MPC8323E Chip Errata

This document details all known silicon errata for the MPC8323E and MPC8321E. The following table provides a revision history for this document.

Figure 1. Recommended connections for DDR controller and memory

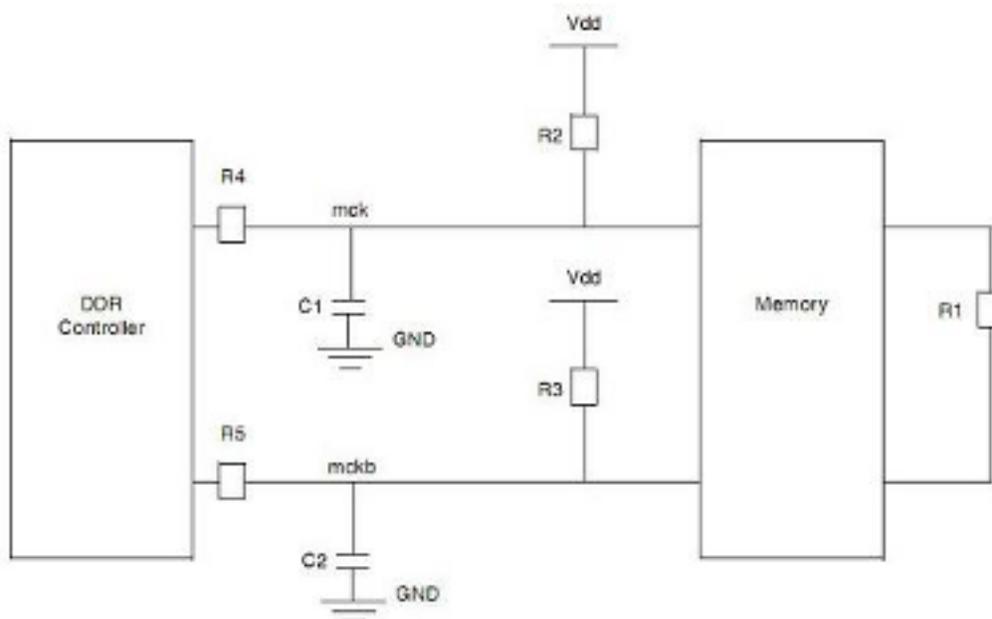
DDR21: MCK/ $\overline{\text{MCK}}$ AC differential crosspoint voltage outside JEDEC specifications

The crossover points of the MCK and $\overline{\text{MCK}}$ signals of the DDR controller are not meeting JESD79-2C specifications, which indicates that the crossover points should lie within ± 125 mV range of reference voltage.

Workaround: To meet the JESD79-2C crosspoint voltage specifications, we recommend implementing the following connections between the DDR controller and DDR2 memory:

1. Increasing R2 and R3 shifts signal levels up (used as pull up).
2. Increasing C1 increases rise/fall time of mck signal.
3. Increasing C2 increases rise/fall time of mckb signal.
4. Reducing R1 can help in shifting the signals up.
5. R4 and R5 can be used to make termination proper.

R4, R5, C1, C2 near to SOC, R1, R2, and R3 have been placed at the end of clock transmission lines.

We recommend varying termination resistor R1 first. Lowering R1 can help increase the voltage levels up. The only disadvantage is that it may add up more reflections. Therefore, the user must decide accordingly. If it does not give sufficient margin, the user can add the pull-up resistor (R3 and R4) option to further increase the voltage levels.

Figure 2. External Logic To Generate Gated Clock for the UCC

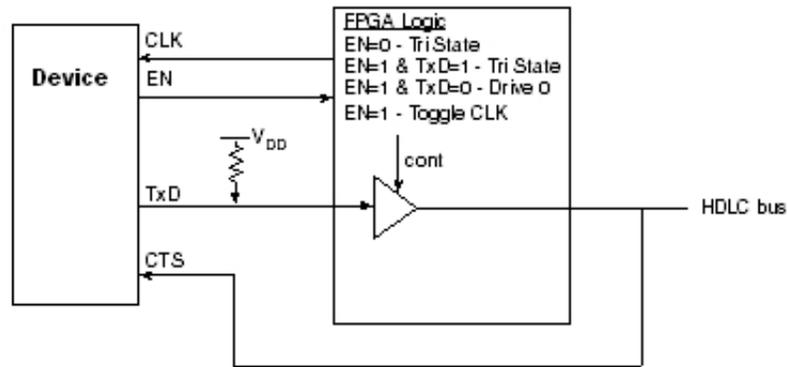
Impact: HDLC bus mode is not supported through the TDM interface.

Workaround: Program the UCC to NMSI mode and use external logic to generate the gated clock for the UCC at the assigned time slot, see Figure 1 below.

Figure 3. Falling Edge (FE) Effect When CE=1, FE=1 and xFSD=00.Sync starts before rising edge

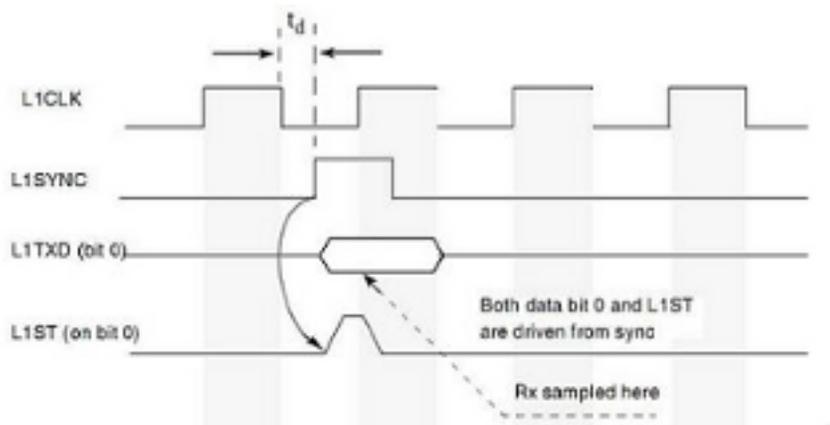
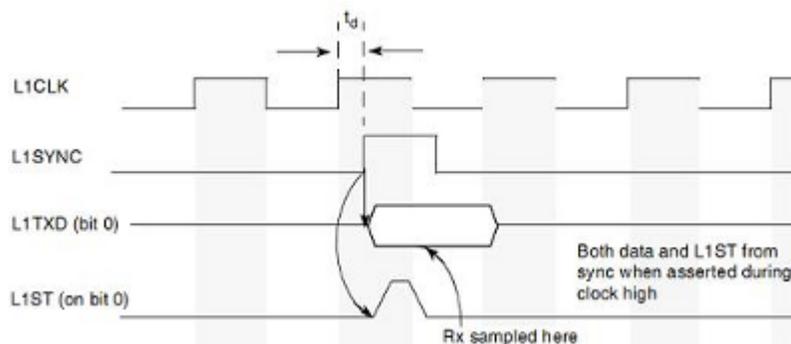
The clock ratio between the TDM clock and the QE clock is limited to 1:24 (the TDM clock can not be faster than QE clock divided by 24), except for the following clock to sync relationship:

- The limitation is 1:32 when $SlxMR[CE] = SlxMR[FE]$, $SlxMR[TFSD] = 00$, and the sync has the timing shown in Figure 1 and Figure 2. In these configurations, $SlxMR[8]$ should be set and in addition to this limitation, the maximum delay between L1CLK and L1SYNC t_d should be less than 8 QE clocks.
